This is to certify that CARRIERE NOREITA E & LAUDE M CARRIERE JTS/ Property
has permission to Single Family Home w/ attached garage suite & 24' attached garage, entry way & 3/4 bath
AT 64 BROOK RD L 375 C028001

City of Portland, Maine - Building or Use Permit Application

Permit No: 08-0338	Issue Date: MAY 21 2008	BL: 375 028001
-----------------------	-----------------------------------	-------------------

City of Portland, Maine - Building or Use Permit

Revised Windows & doors schedule (64 Brook road)

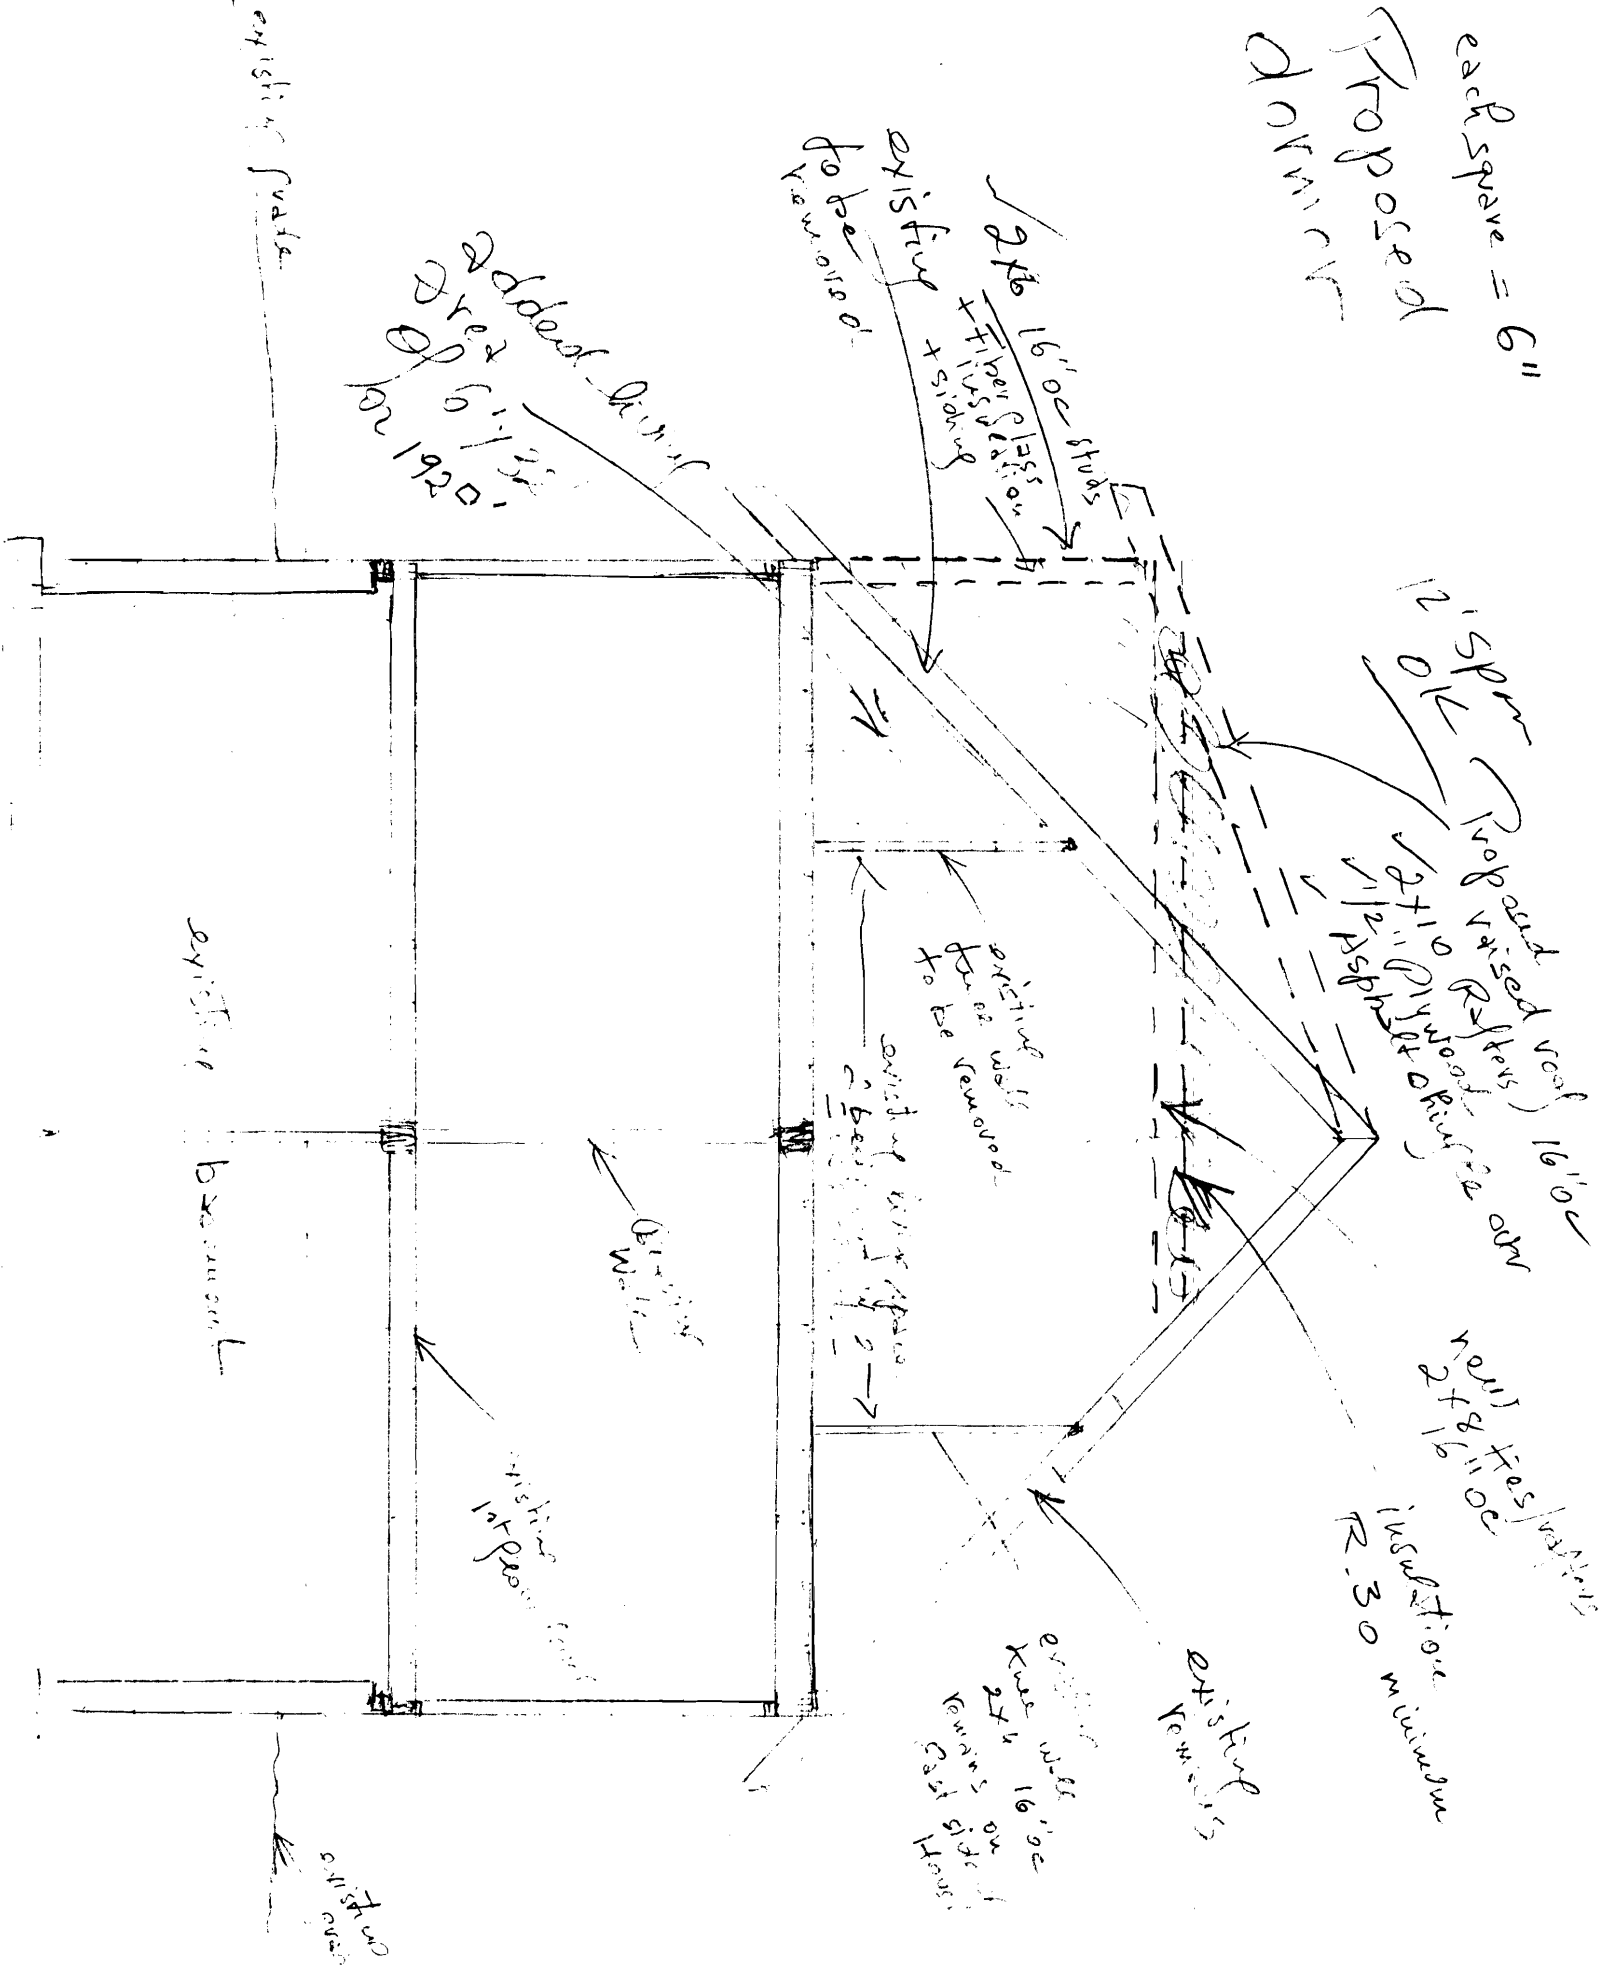
- 1) The attic scuttle opening must be 22" x 30".
- 2) There must be a 2" clearance maintained between the chimney and any combustible material, with draft stopping per code at each level
- 3) Hardwired interconnected battery backup smoke detectors shall be installed in all bedrooms, protecting the bedrooms, and on every level.
- 4) Permit approved based on the plans submitted and reviewed w/owner/contractor, with additional information as agreed on and as noted on plans.
- 5) Separate permits are required for any electrical, plumbing, or HVAC systems. Separate plans may need to be submitted for approval as a part of this process.

① Beam under garage knee wall to be laminated of (4) 2"x12" kd - spruce/pir

② Beam over garage door to be laminated of (3) 2"x12" kd spruce/pir

③ Steps in entry room to have 7 1/2" risers and 11" treads -

④ Chimney wall clearances to be a minimum of 2"

⑤ Hard wire smoke detectors will be installed in upper bedrooms - #1 & #2 -

⑥ Access to garage loft will be with ceiling retractable system -

Item #	Description	Notes
W # 1	existing window removed & replaced by High Horizontal insulated window 60" x 24"	(Bed. room # 1) — 4 x 8
W # 2	insulated 44" x 52" (egress requirement met)	(Bedroom # 1) — 6 x 6
W # 3	insulated 44" x 52" (egress requirement met)	(Bedroom # 2) — 6 x 6
W # 4	insulated 27 x 44	(new bath) — 6 x 6
D # 1	30 x 78 existing hollow core	(Bed room # 1) — Unknown
D # 2	30 x 78 existing hollow core	(Bed room # 2) — Unknown
D # 3	30 x 78 hollow core	(new bath room) — 4 x 6
W # 4	Fixed insulated glass 24 x 68	(Garage) — 4 x 6
W # 5	insulated 30 x 52	(Garage) — 4 x 6
W # 6	insulated 30 x 52	(Garage) — 4 x 6
W # 7	insulated 30 x 52	(Garage) — 4 x 6
D # 4	36 x 80 fiberglass insulated with side light	(entry) — 6 x 8
D # 5	32 x 80 Self closing steel fire door	(Garage to mod-room-entry) — 4 x 6
D # 6	Wood door - 1/2 glass top	32 x 80 - (garage rear exit) — 4 x 6
